Ella Bay Integrated Resort Proposal

Supplementary Environmental Impact Statement

Submission Response:
1.8 DEWHA, EPA &
WTMA December
2007 (Addenda A)

1.8 DEWHA, EPA & WTMA December 2007 (Addenda A)

Figure 1.8.1: Access Road clearing plan (located in Volume 3, Section 3.2).

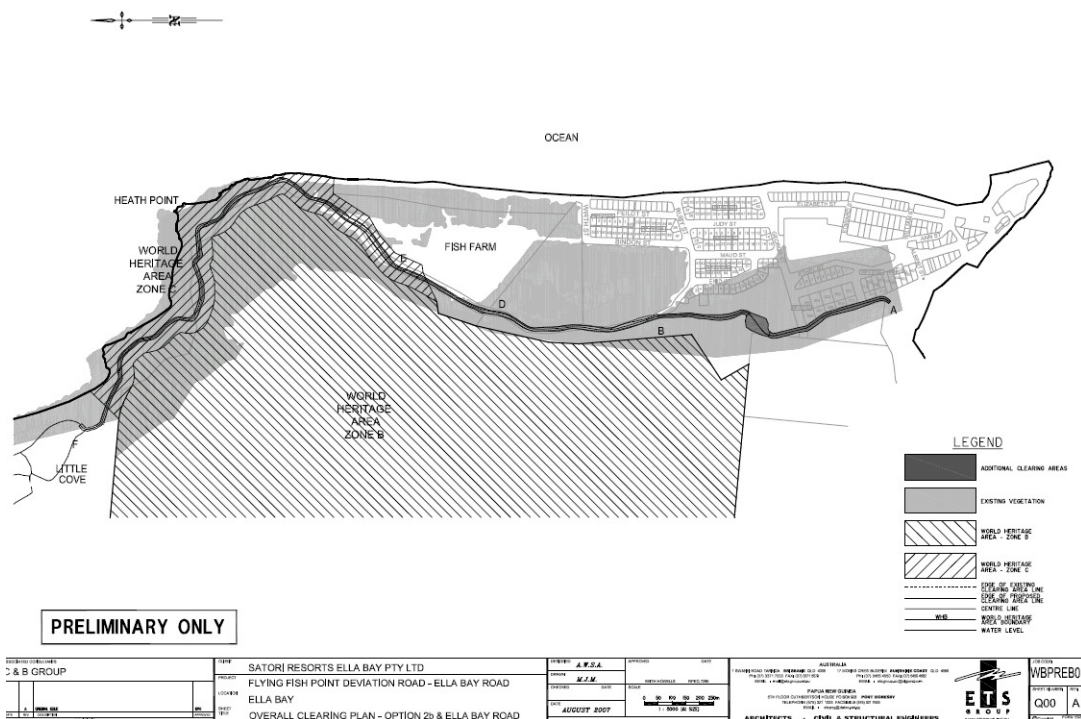
According to the fauna and flora report, an additional area of approximately 12 hectares of potentially suitable habitat for EPBC listed species will be cleared to facilitate the access road construction.

The figure indicated in correspondence dated 18th January, 2008 of 12 hectares of clearing is a misinterpretation. Table 7.4 in the Access Road Strategy (BAMM Section) should not be used to calculate a total clearing figure. The table indicates the area of potential habitat for each individual flora species that may be subject to clearing and therefore these clearing areas overlap.

The following figures (Figure 1.8.1 and 1.8.2) indicate the approximate areas to be cleared along the road alignment and onsite.

Figure 1.8.3: Draft SEIS preferred access route (Volume 3, Section 3.1)

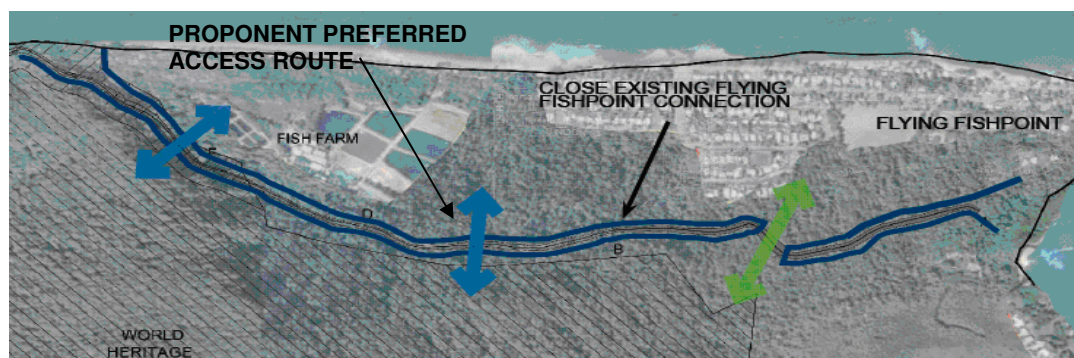
Additional road options suggested by government environmental agencies exist that require detailed examination:

- An alignment that passes through a cut and cover tunnel along the foot of the hill-slope, then runs east on Ruby Street, north along Bindon Street, continuing to the boundary of the Fish Farm and then running north-northwest.
- A new route should be discussed in the SEIS which skirts around lots 18USL35566 and 246NR3550 (some clearing on the eastern and southern margin of the rainforest block may be necessary to provide a buffer to existing residential development, however this would be offset by closing and revegetating the existing road to the west). A bridge to facilitate wildlife movement should be provided on this road alignment option, on the north-eastern side of lot 246NR3550

The proponents Draft SEIS preferred access route, bypassing Flying Fish Point is shown in the following diagram.

Figure 1.8.4: Preferred access route and Option RB1

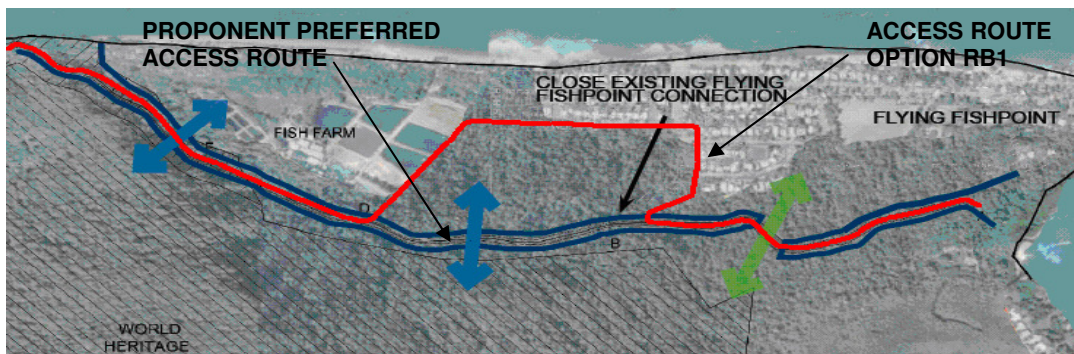
Government environmental agencies requested that the proponent examine a modification to the preferred option that involves the route running east on Ruby Street, north along Bindon Street, continuing to the boundary of the Fish Farm and then north-northwest before joining the existing Ella Bay access road. This access route alignment is indicatively shown in Figure 1.8.4 and has been nominated as Option RB1.

The option RB1 suggested by the Wet Tropics is somewhat similar to the option proposed by the EPA at the EIS stage, but avoids the route passing through the major residential area of Flying Fish Point.

However, this road option would still directly pass more than twenty existing residential dwellings and three intersections creating noise, pollution, safety, congestion and other adverse residential amenity issues. It

In regard to transport efficiency, this route rates poorly because of the number of sharp bends, intersections, increased distance, slower speed, increase travel time, and reduced safety to road users and pedestrians. The total length of this road option between Flying Fish Point and the Fish Farm is approximately 1140 metres, which is approximately 500 metres longer than the preferred route.

This route performs well environmentally as it would allow for the existing Ella Bay Road to be closed and revegetated, providing better connectivity between the Ella Bay National Park and environmental reserve. Some clearing would still be required along the Fish Farm boundary. However, socially and from the local community's perspective this option rates poorly and somewhat defeats the purpose of building a bypass around Flying Fish Point.

Figure 1.8.5: Preferred access route and Option RB2

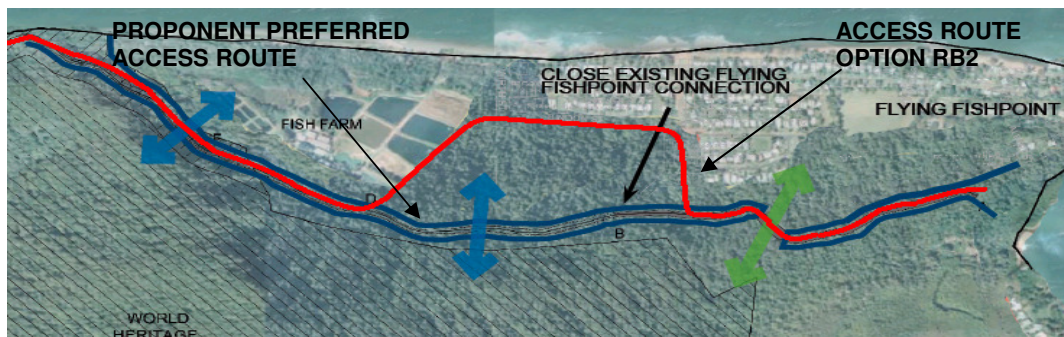
The Queensland Environmental Protection Agency also suggested the proponent examine a similar option that involves setting the road back from existing residents at Flying Fish Point, providing a vegetated buffer to mitigate possible social issues. EPA has suggested a 20 metre vegetated setback. This access route alignment is indicatively shown in Figure 1.8.5 and has been nominated as Option RB2.

The option RB2 is a variant of option RB1 and was suggested by the EPA. It follows a similar alignment to RB1 but includes a 20 metre vegetated buffer to existing residents along Ruby and Bindon Streets, and the

This road option would pass through the vegetated environmental reserve and require approximately 1.02 hectares of clearing of 'of concern' vegetation. However, the clearing would be partially offset by closing and revegetating the existing Ella Bay Road. A vegetated buffer may partially mitigate some of the social impacts on the Flying Fish Point community that were associated with option RB1. The vegetation would provide a visual screen to the road, however noise may still impact upon residents.

Option RB2 is marginally better in terms of transport efficiency and safety compared to option RB1, however the road now divides the environmental reserve and partially segments habitat. A fauna underpass between Flying Fish Point and the Fish Farm could mitigate some environmental impacts, however the area on the eastern side of the road would be long and narrow and of reduced environmental value. This route also passes through wet areas which raise further environmental, constructability and cost issues.

Figure 1.8.7: Access route option RB2

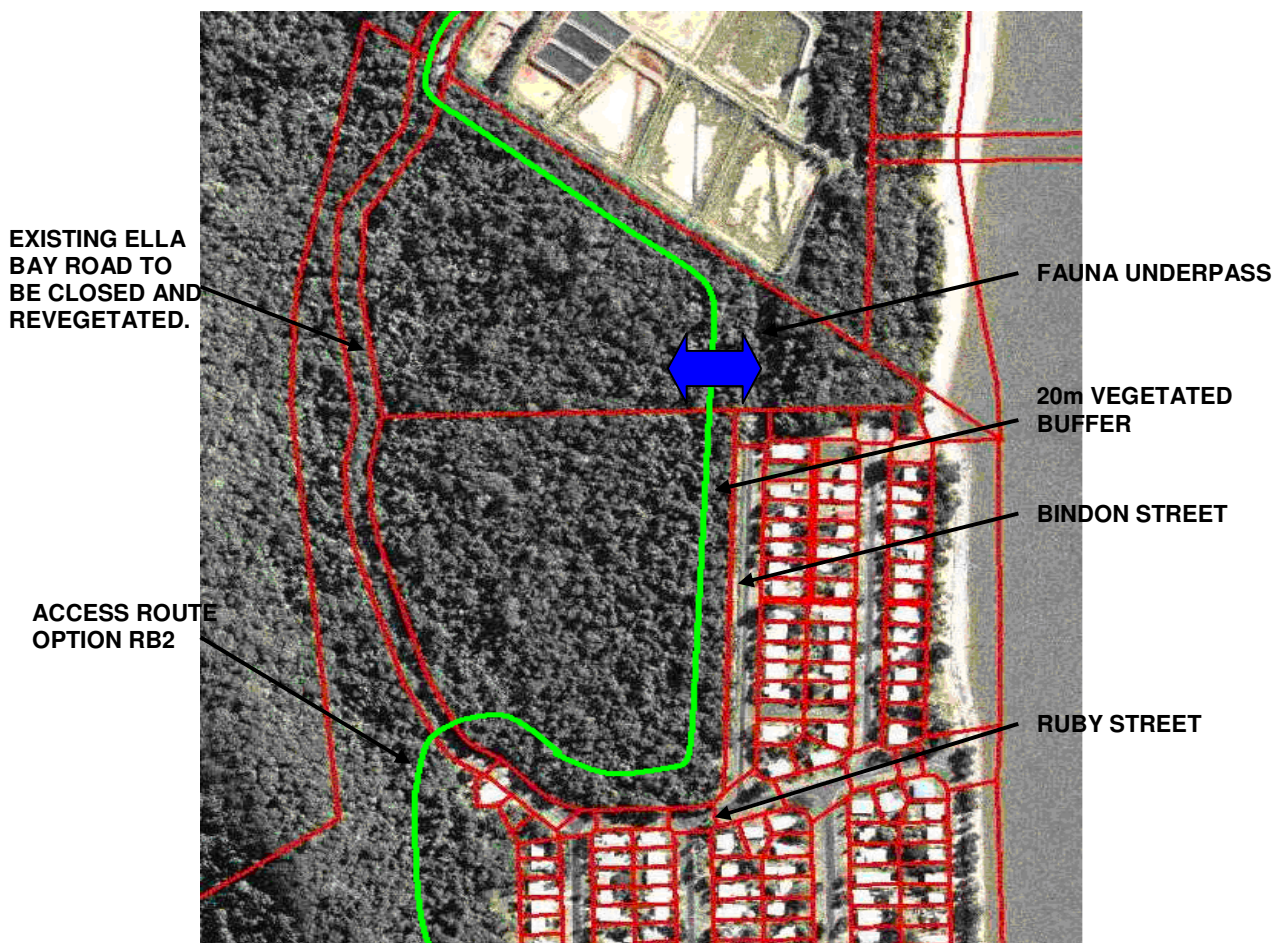
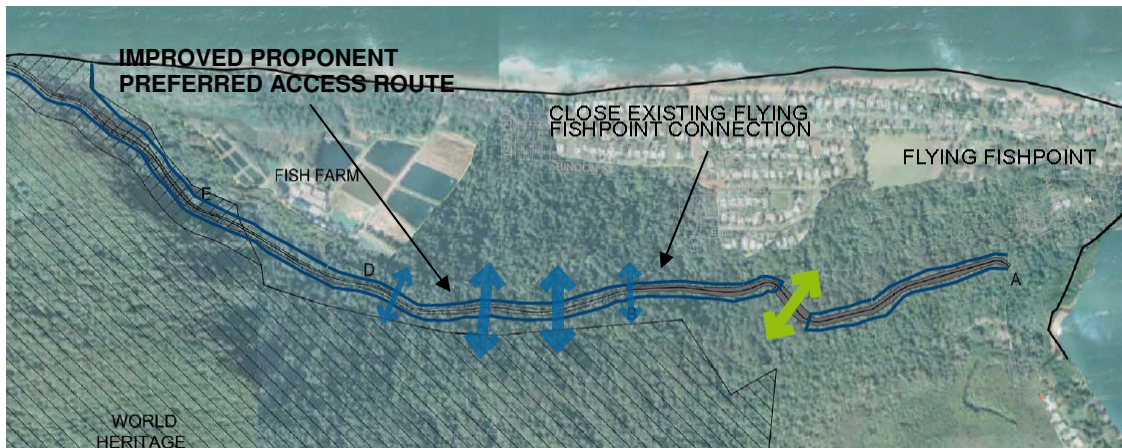
The addendum re-runs the road multi criteria analysis to include the two additional options RB1 and RB2 and analyses in more detail the different road sub-options

The route is now proposed to include four fauna underpasses that will enhance connectivity and reduce the risk of potential road kill. The crossing points are indicated in the following figure (Figure 1.8.8).

Figure 1.8.11: Little Cove Access Road Strategy

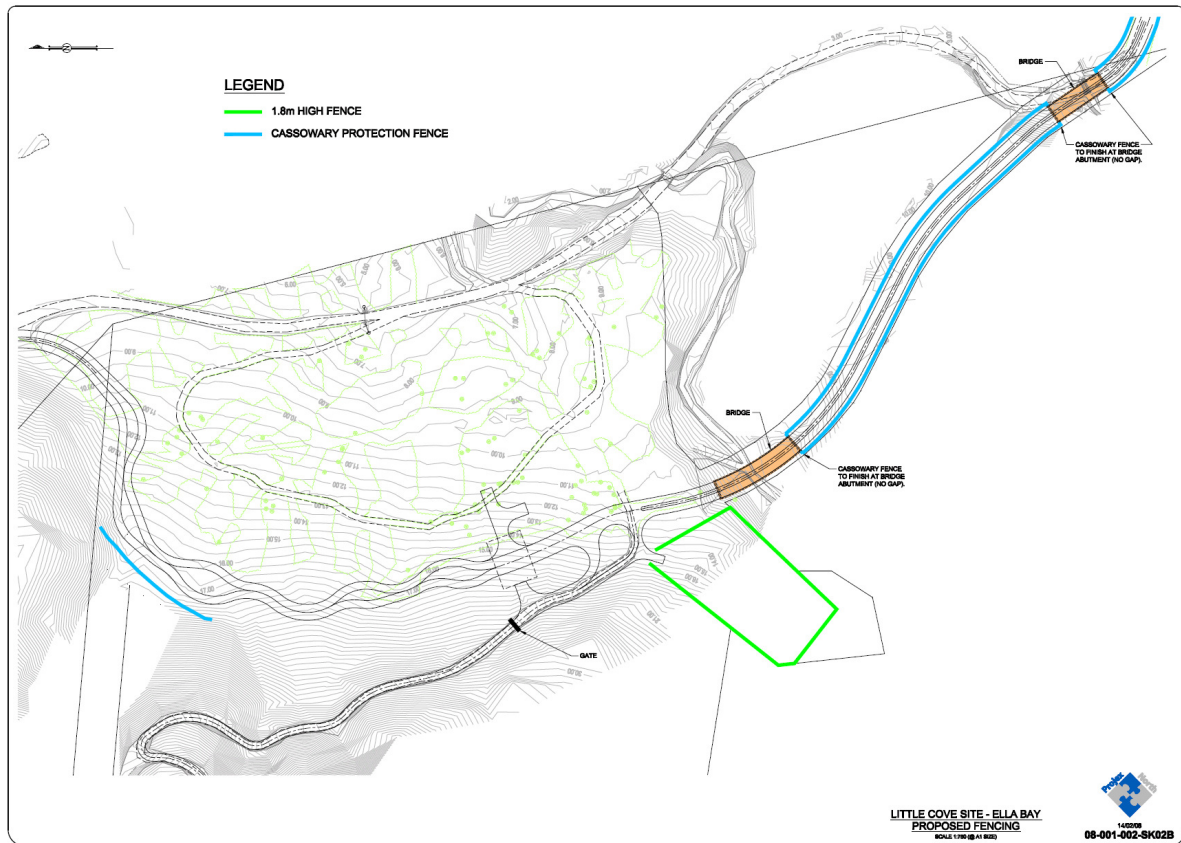
The proposed road alignment to the north of Little Cove should be provided with strategies that are proposed to mitigate the impact of traffic on fauna between Little Cove and the proposed Ella Bay Integrated Resort

The Little Cove entry road contains varying terrain from relatively flat to steeply sloping areas around the headland. A suite of mitigation measures are required.

The southern entry of the property to the creek (bridge to bridge) of approximately 400 metres is relatively flat and cassowaries are known to frequent this area. Cassowary exclusion fencing will be installed on both sides of the road to the bridge. The bridges will have handrails and by their nature will be Cassowary exclusive. The entry road will have Cassowary warning signs and traffic calming measures to reduce speed. The traffic calming in this area will be a combination of speed humps and curved roadway. This area due to the mitigation measures will have an initial signposted speed of 60km/h slowing to 40 km/h approaching the second bridge near the resort. The roadway will have two lanes of 3.5m width and a 2m bicycle/walking lane and a vegetated verge on either side to allow any trapped birds to move off the pavement.

The area from the bridge over the creek to the resort is characterised by a cutting through the northern bank of the creek gully, road intersections and pedestrian movements of the resort. The fencing will be contiguous between the bridge and the infrastructure area. The infrastructure area will be fenced to 1.8m

The zone from the infrastructure area to the resort will have frequent car and truck turning movements into and out of these areas to access the resort, residential and back of house central facilities. This zone will have traffic calming which does not generate excess noise to resort residences. Traffic calming will comprise a combination of speed signs, localized road narrowing and chicanes required to slow the traffic to 20km/hour. The road will also have split lanes where required to retain the major trees. The alignment shown in Figure 1.8.11 is indicative as detailed surveying of the trees and route have not been completed. The road from the hilltop residences will be gated above the resort entrance to prevent any Cassowary movement from the hill top to the resort and roads.

The western side of the road will not be fenced as the hillside above the resort is considered too steep for Cassowary movement except for Cassowary fencing of the gully between the steep ridges as the road winds around the point to the Ella Bay property. It is proposed to fence only the gully on the western side of the road between the steep roadside with Cassowary exclusion fencing. The Gully is short and quite steep in upper reaches and Cassowary movement would be unlikely. The western side of the road around the point to the Ella Bay property to the North is too steep for Cassowary movement.

Figure 1.8.13: Revised master plan showing changes made to the western boundary (Volume 3, Section 3.1)

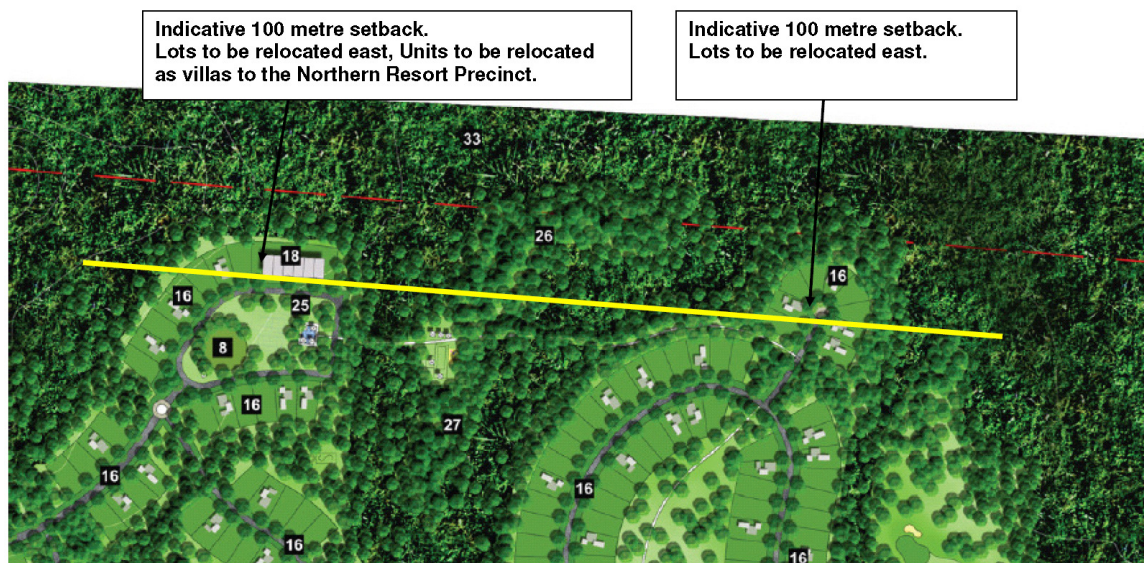
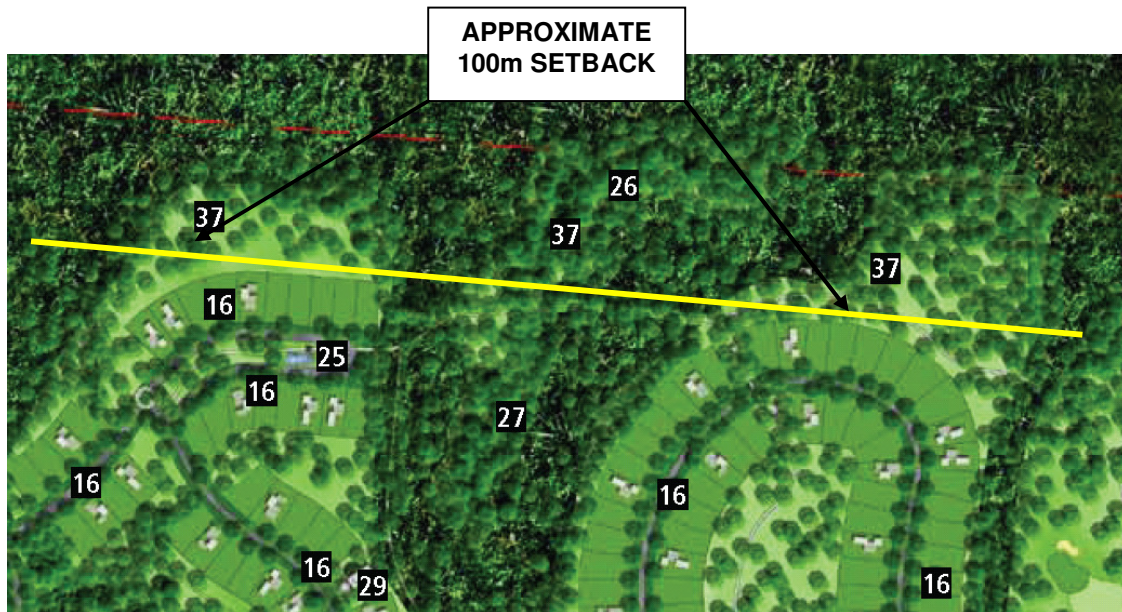
Minimum setback along the western and southern boundaries should be increased to at least 100m.

- The setback of residences on the western boundary has been increased from 50 metres to 100 metres.
- The three storey apartments indicated in the EIS and Draft SEIS Master Plan have been relocated from the western boundary and will now be incorporated as villas in the northern resort.
- The setback of the residential allotments on the southern boundary have been increased from 50 metres to 100 metres.

The proposed changes outlined above are indicated in the following figures and are now reflected in the new master plan.

Figure 1.8.17: Revised master plan showing the BBQ area removed (Volume 3, Section 3.1)

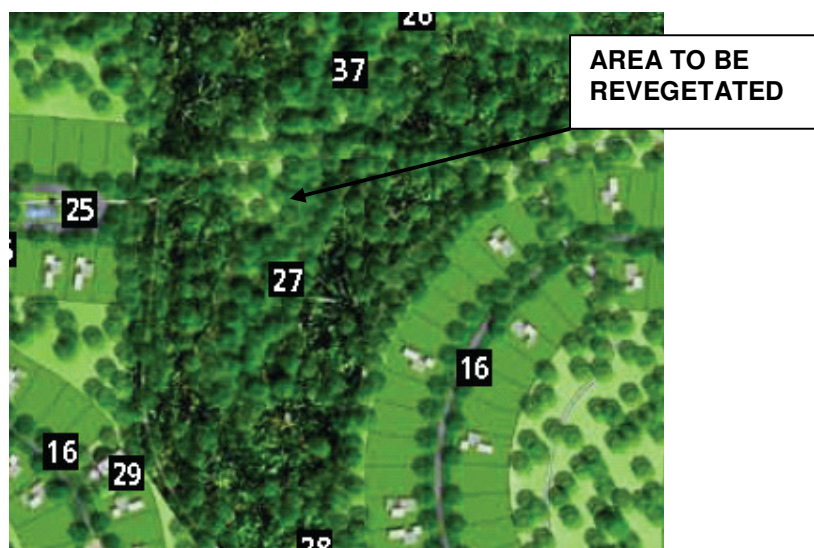
The barbeque facility within the bifurcated vegetated area to the west should be relocated.

The proponent confirms that the bifurcated area between the fork of the north-south running creek will be revegetated and the barbeque and recreational facilities will be removed. These changes have now been incorporated into the current master plan as indicated in the following images.

Figure 1.8.21: SEIS with 100m wide northern fauna corridor

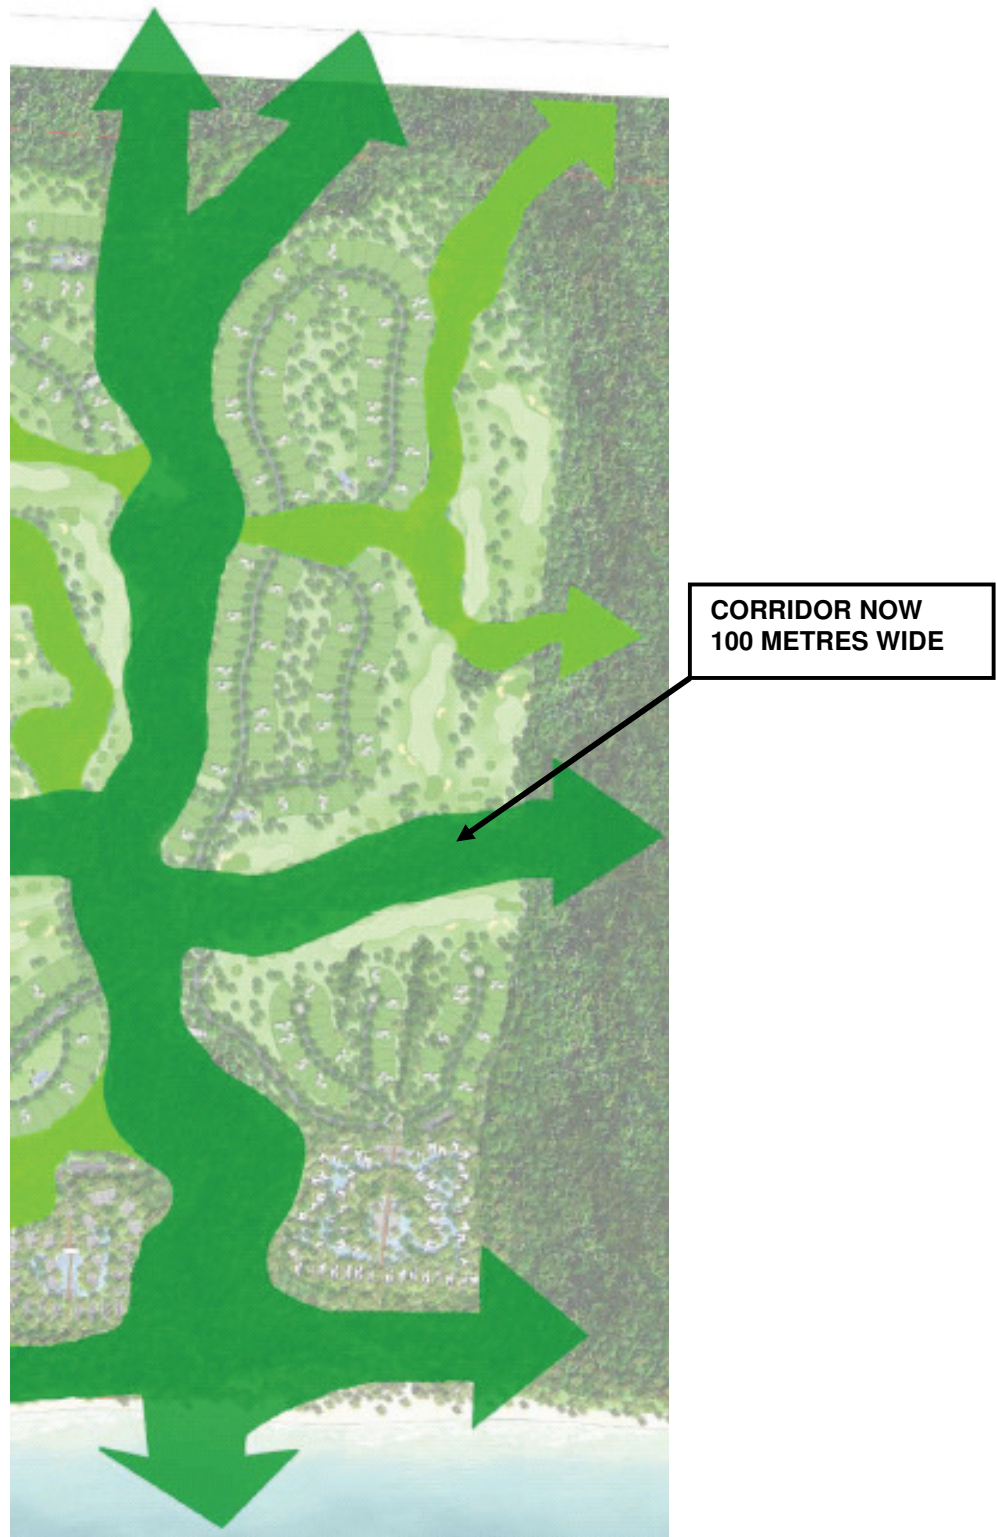
Northern part of the north-south fauna corridor should be expanded to 100 metres.

The north-south corridor has now been expanded to 100 metres. The following figures show the original EIS master plan with no northern corridor (Figure 1.8.18), the Draft SEIS master plan with a 50 metre wide northern corridor (Figure 1.8.19), and now the current SEIS master plan with a 100 metre wide corridor (Figure 1.8.20).
